CITY OF ALBUQUERQUE

OFFICIAL NOTIFICATION OF DECISION

Project #2018-001759
SI-2018-00222 – Site Plan

INSPIRATION

SITE PLAN

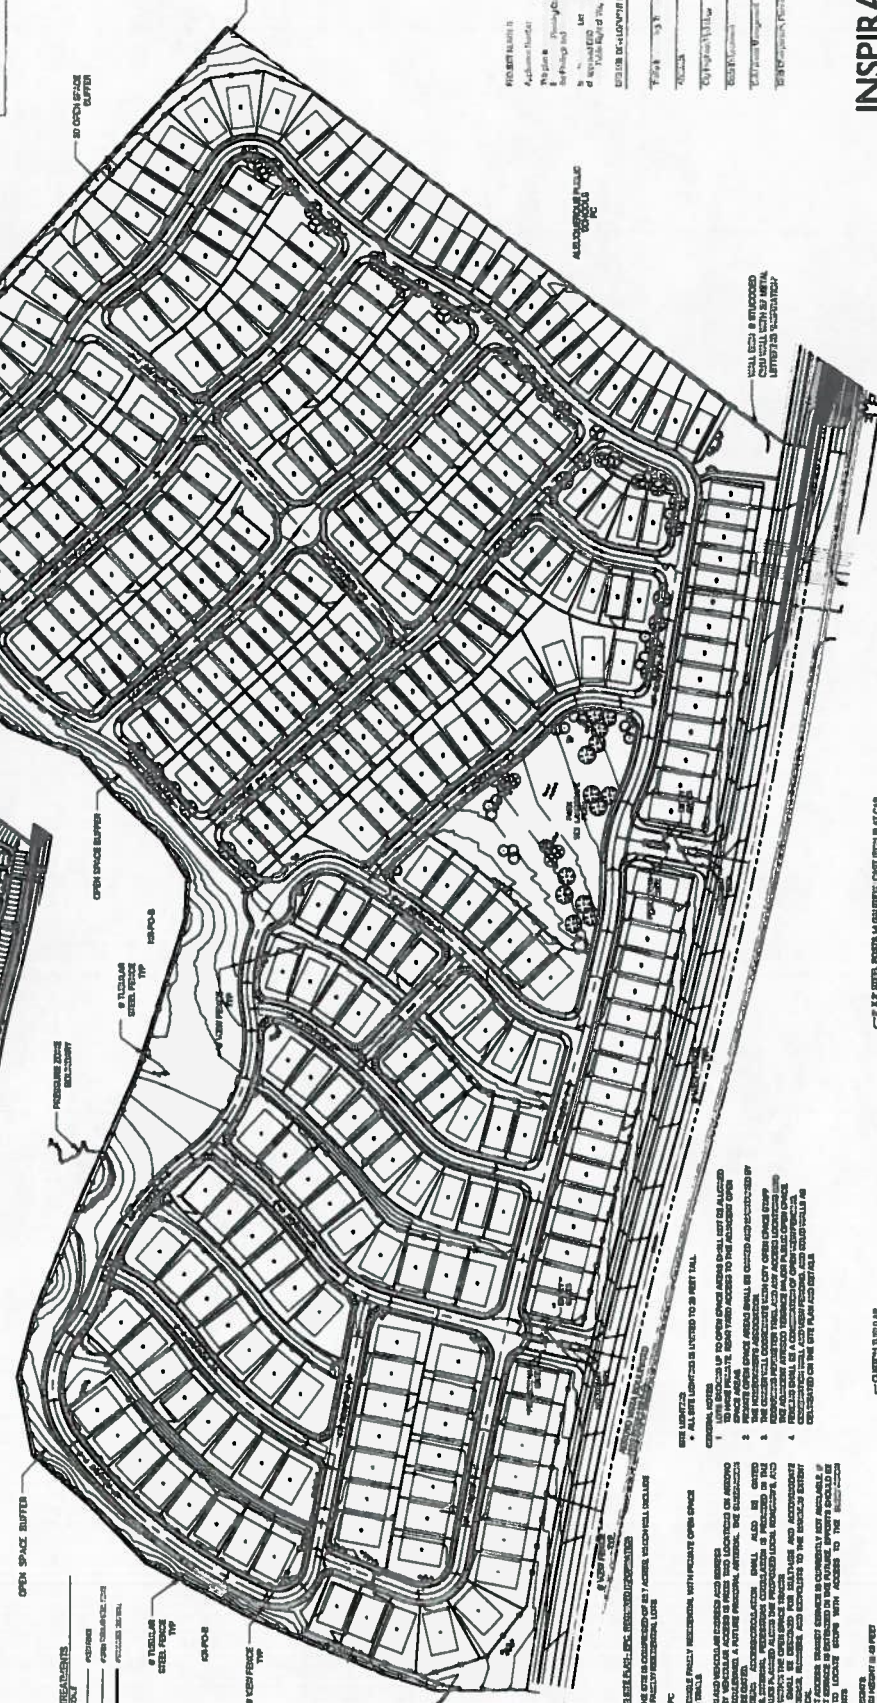
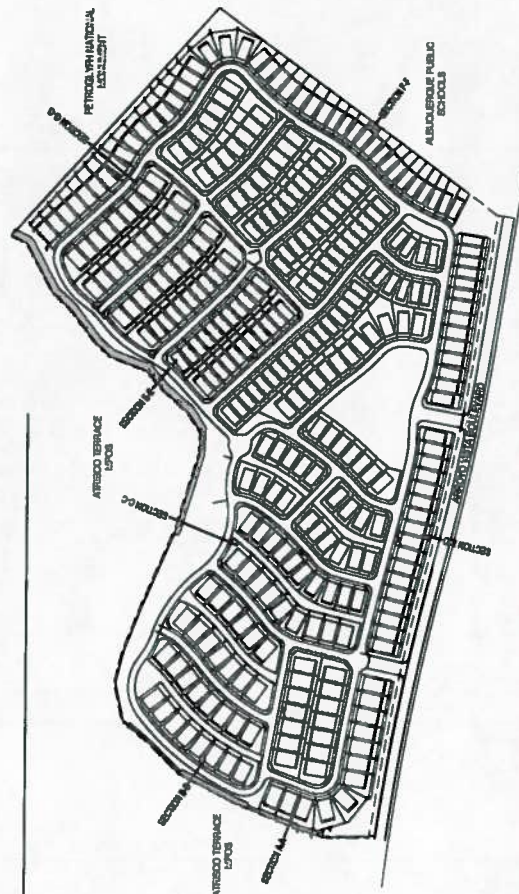
- Minor changes to comply with 5-2(H)1 a - f.
- Building height must be limited to 26 feet.
- The on-site open space (private park) should be relocated northward so that it is contiguous with the Major Public Open Space.

The submitted site plan proposes on-site open space in the form of a private park. This on-site open space should be relocated northward to be contiguous with the Major Public Open Space. This is a recommended condition of approval.

The site plan's note that maximum building height of 40 feet should be changed to 26 feet.

- F. Height in VPO 2 is limited to 15 feet or 19 feet. Please add a note to the elevations sheet and correct this on Sheet 1.

- b. Any notes, as submitted or as amended, that refer to access to open space areas should clarify the notation to be "private open space areas."
 2. The Site Plan will note that building height is limited to 26 feet.
 3. As required by IDO 14-16-5-2(H) and to be consistent with ABC Comprehensive Plan Policies 10.3.5, 11.3.1, 11.3.4 and 11.4.4, the on-site open space (private park) shall be relocated northward so that it is contiguous with the Major Public Open Space.
 4. The applicant shall coordinate with the staff planner to ensure that all Conditions of Approval are met and then submit a vetted, final version to the staff planner for filing at the Planning Department.
-
